Stepper Driver PCB Iterations

Skittle Sorter Project

Jaidon Lybbert, Motor Control Design Lead, EWU IEEE Student Chapter 08/23/20

This document serves as a history for the various changes that have been made to the motor driver PCB design over its many iterations, and why those changes were necessary.

Fig. 2: Trace view of the first PCB design. Notice the poor layout of components, long traces, excessive vias necessary, and ridiculous daisy-chained power supply with slim traces.

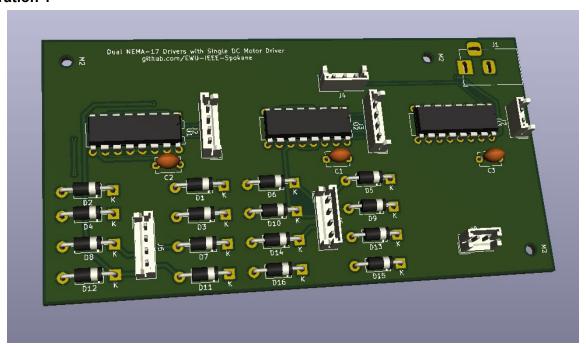
- The power supply is located at one end of the board, and the ICs are daisy-chained together. When one IC draws a lot of current, the ICs up the chain will likely experience a lot of noise at both their logic supply, and power supply inputs.
- The trace widths for the power supply pins are not wide enough. They would burn and short with less than 1 amp of current. Since the chips are daisy-chained, a lot more than 1 amp (closer to 4) could be drawn through these traces.
- There is a lot of unused space on the board. Traces are long, which will increase noise and thermal losses.
- The outputs are far from the ICs and placed in an awkward position, making running traces to them difficult (there are two output pins on either side of each IC) and long.

Figure 4: Iteration 3 of the driver PCB. A small layout means high current traces are kept minimized and direct, and noise is reduced.

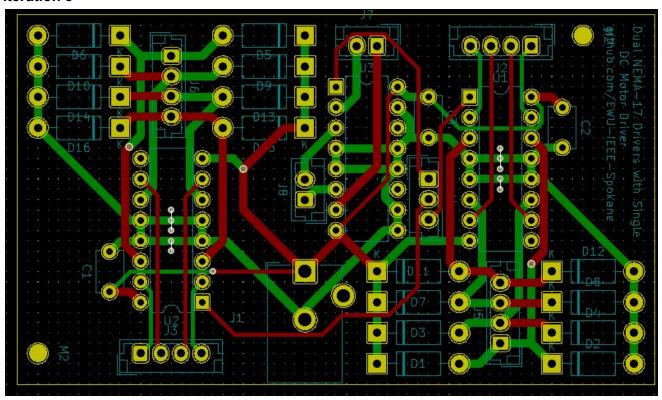
This design will require external heatsinks for the I293B chips as there is simply not enough copper on the ground planes to dissipate the heat

- Total area is reduced from 64 cm² to 34 cm² when compared to iteration 1.
- Power connections are direct (the daisy-chaining seen between U1 and U3 does not occur in the design, that is the one modification not shown here).
- Thermal vias are included to conduct heat from the center of each I293B to the ground plane on the backside of the board.
- Total number of vias (excluding thermal vias) is reduced from 9 to 4.
